SUBJECT: Forwards schedule of submittal of addl info requested as result of 860710-11 audit of util emergency operating procedures. Audit comments documented in NRC 860804 trip rept & discussed at 860814 meeting at plant.

SHEARON HARRIS NUCLEAR POWER PLANT  
UNIT NO. 1 - DOCKET NO. 50-400  
EMERGENCY OPERATING PROCEDURES

## GENERAL SCHEDULE

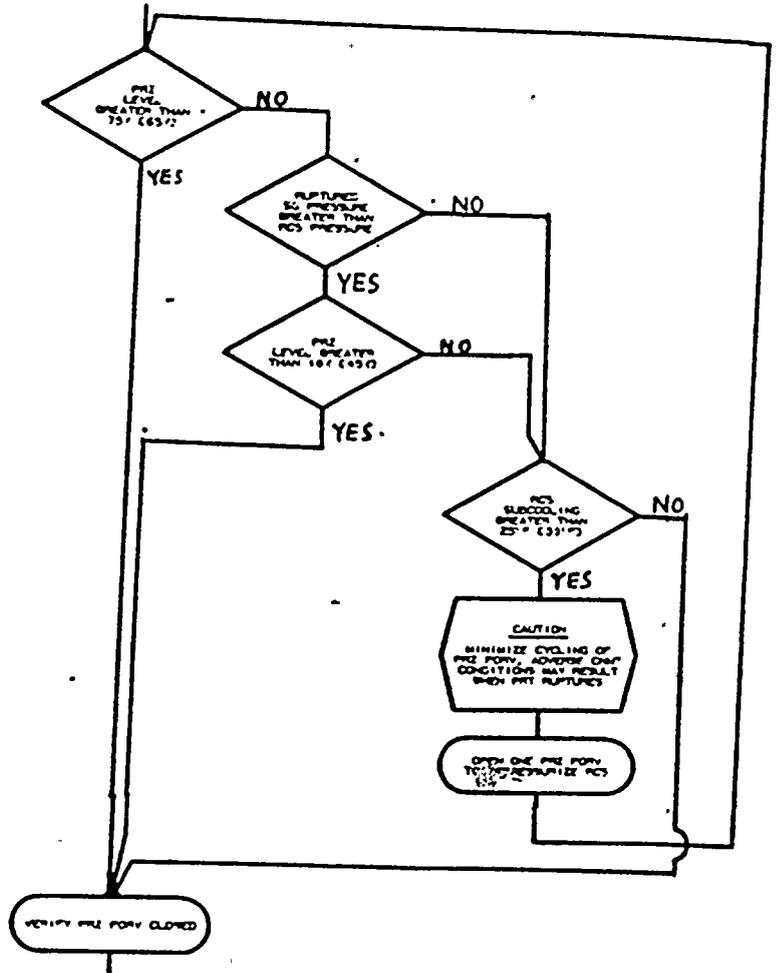
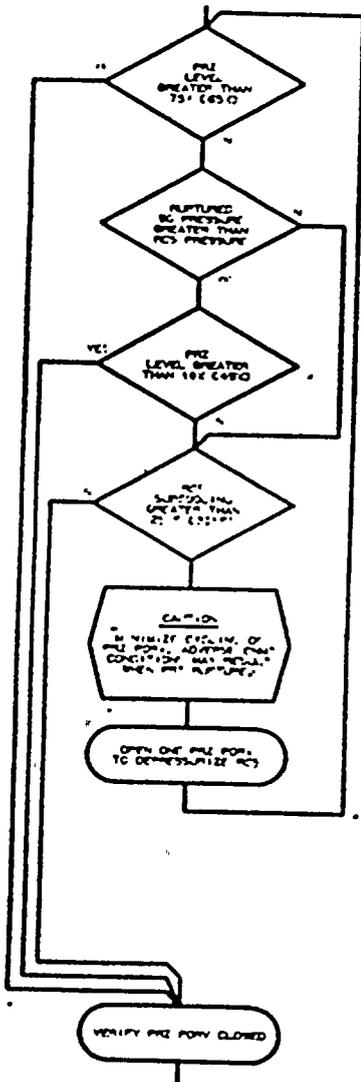
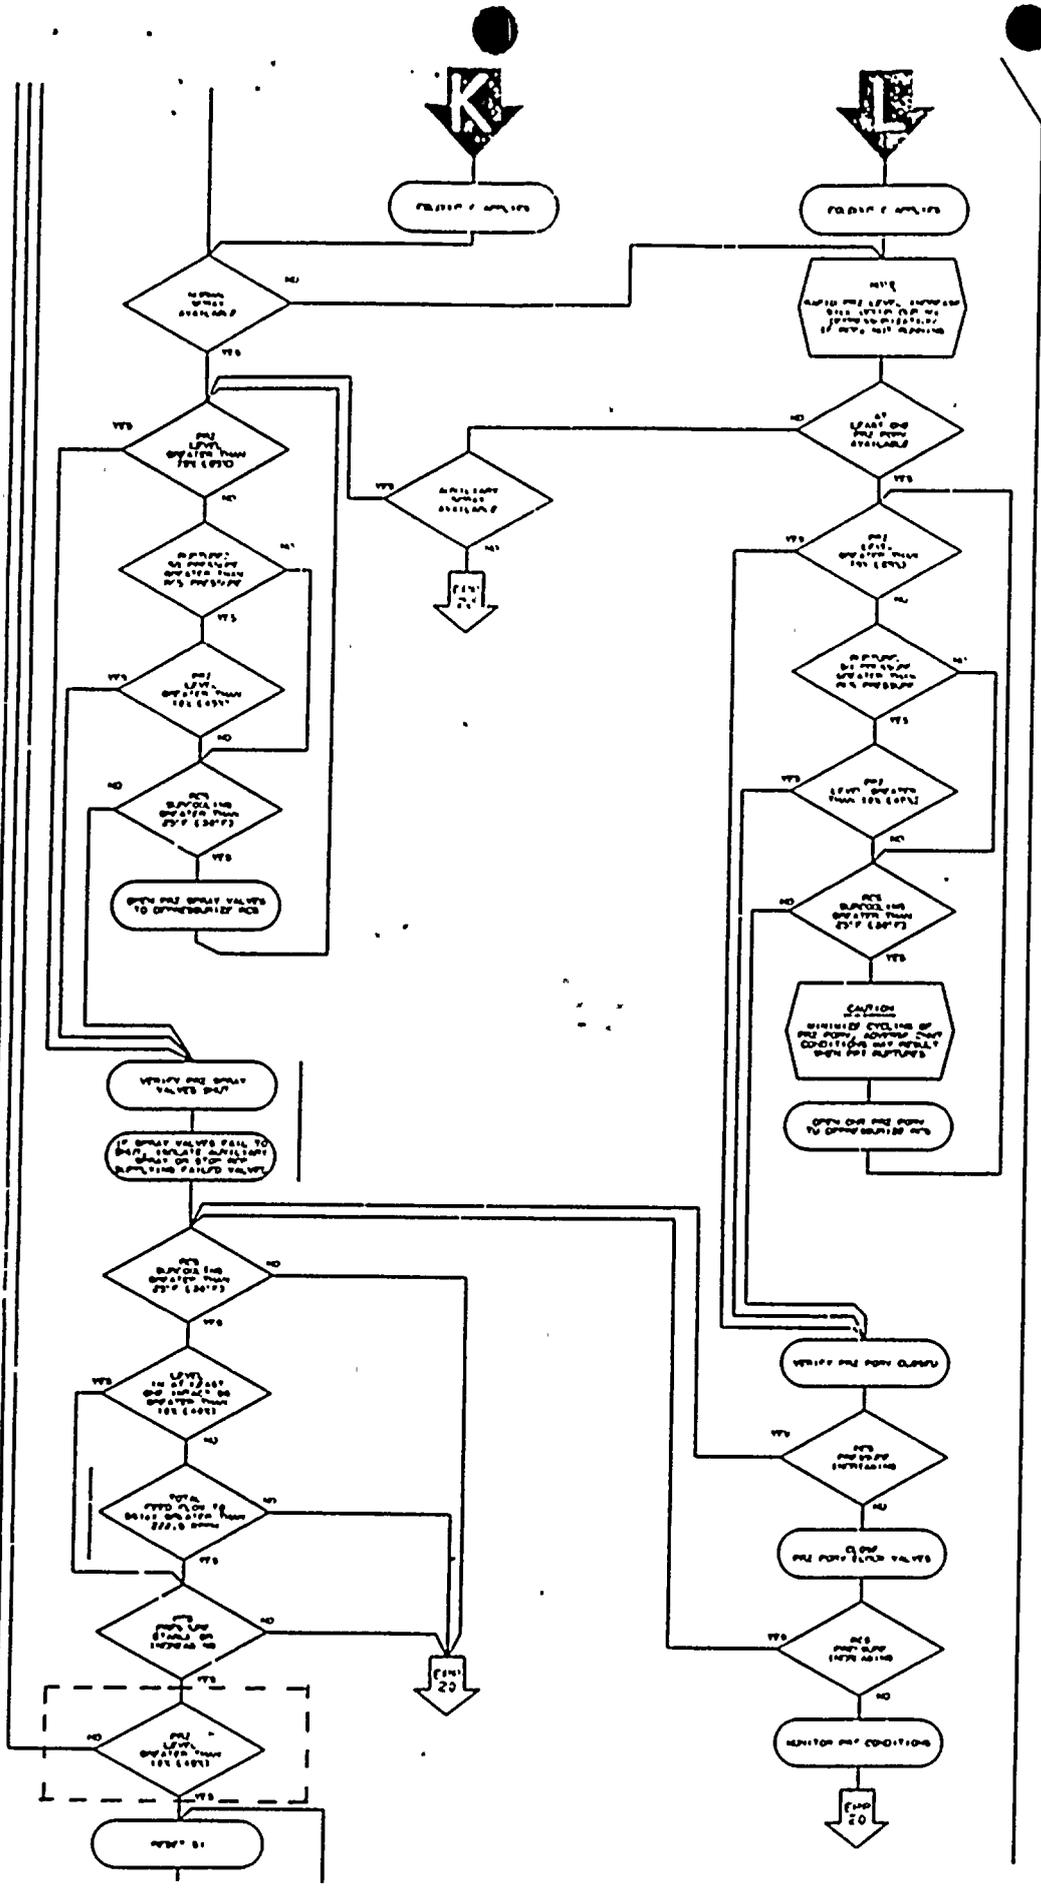
- f. Decision symbols used on flowcharts should be consistent in size, color, and design. The writer's guide should be expanded to include explicit instructions on the location of the "yes" and "no" indicators on decision symbols including a commitment to use the same format in every possible situation (e.g., if the response is "yes," movement is down, if the response is "no," movement is to the right).

These blocks if re-arranged would still result in crossed lines and inefficient use of space.

If the NO were to exit out the right of the indicated box it would have to cross other lines, or the board would have to be restructured, greatly increasing its size.
